Flex-G Minor Modifications onto the Flex-G Serial Number 01 (SN01)

Atsuhiko Konosu
Japan Automobile Research Institute (JARI)

Long bones

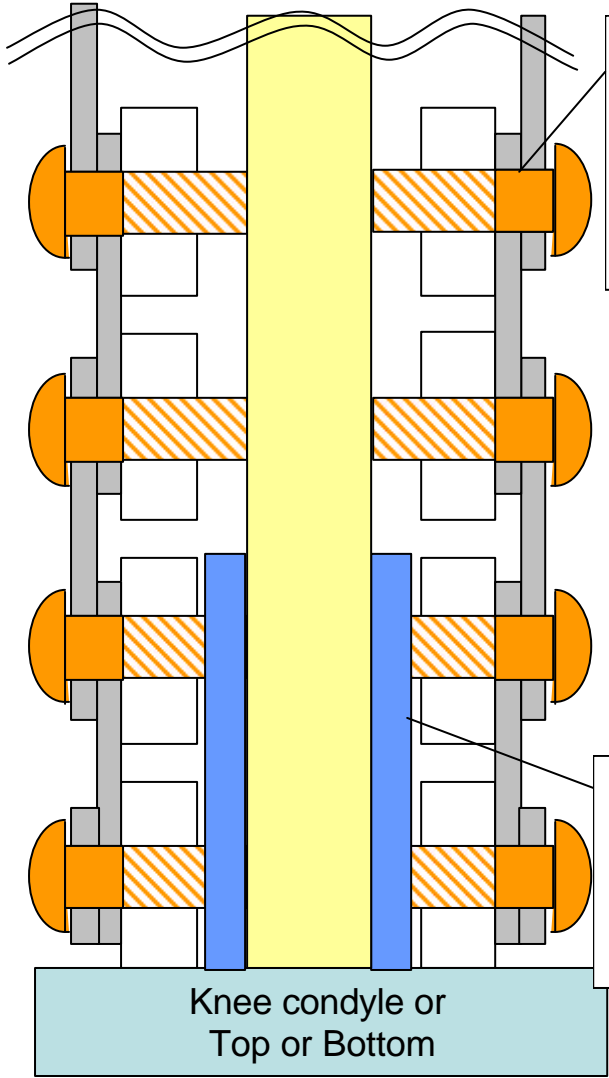
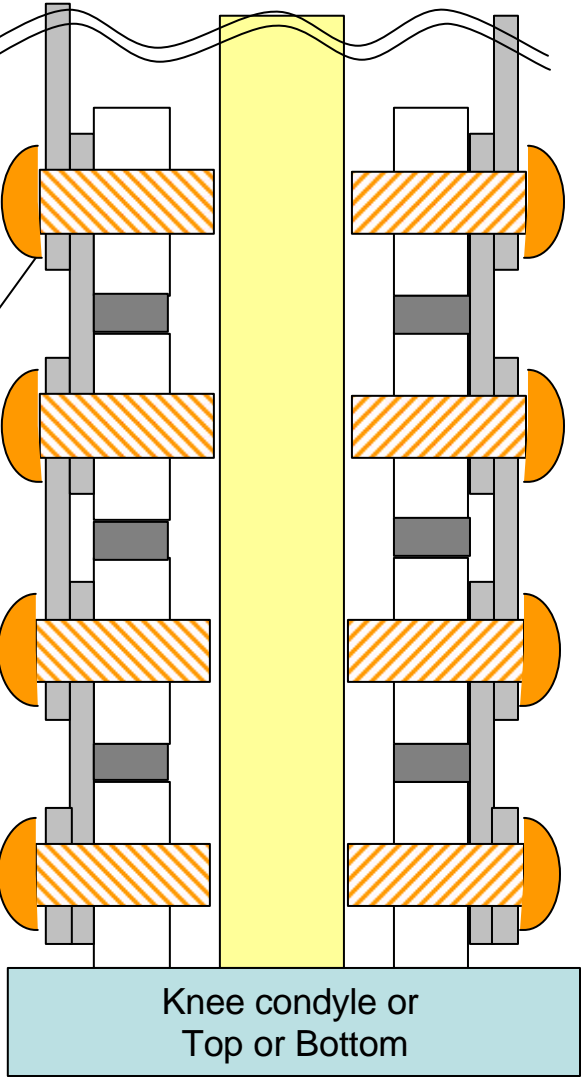
Need to make small gap by users

stop at a certain depth automatically and make a small gap automatically

added support spacers to sustain the bone core more strongly

Knee joint (1)

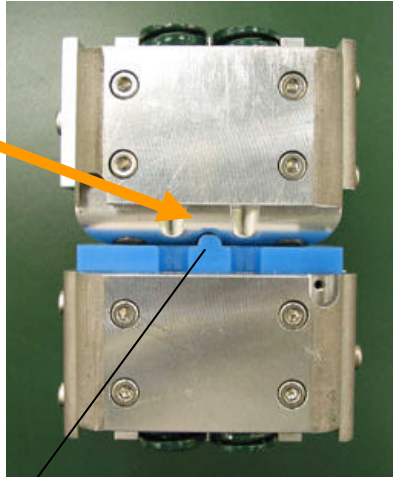
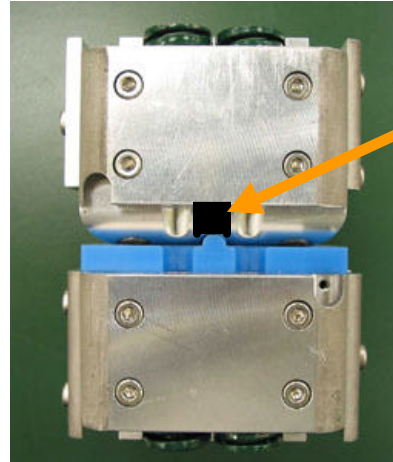
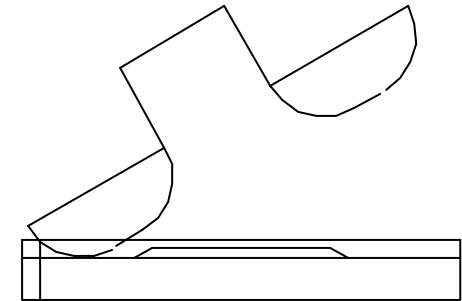
condyle eminence is attached to the groove

tend to do not make damage at the condyle eminences.

Knee joint (2)

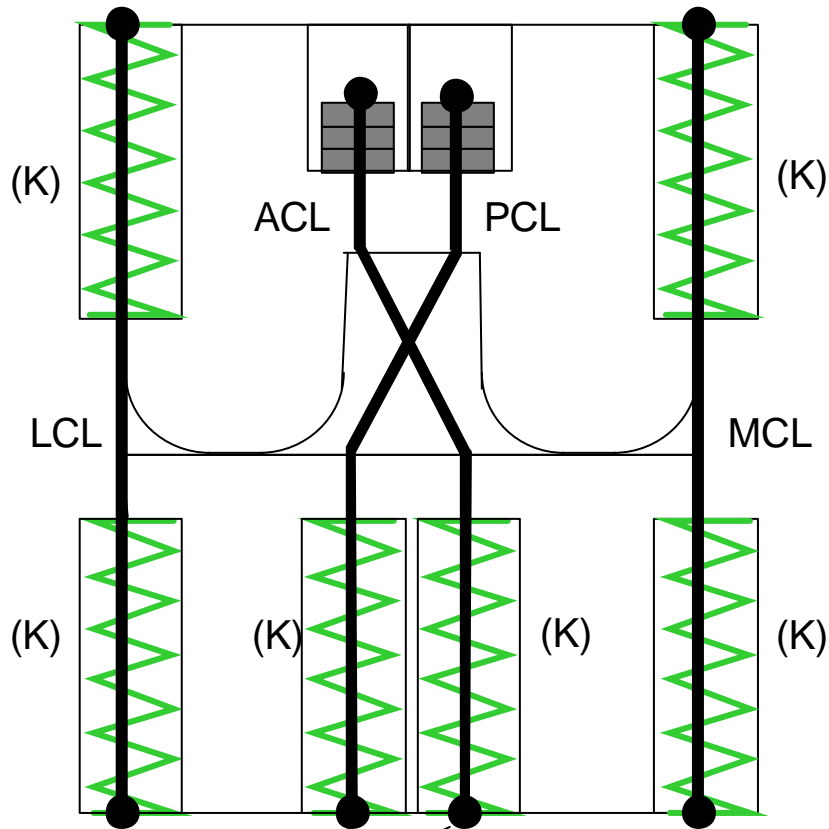
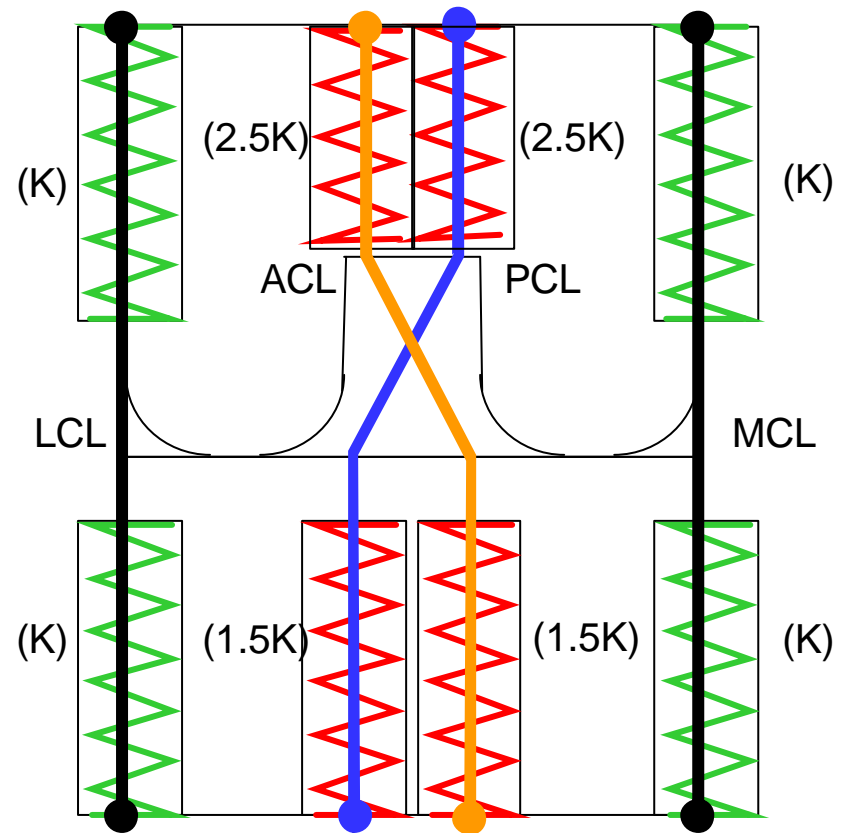
only one side cables are moving

can move both side of the cables (same as LCL/MCL)
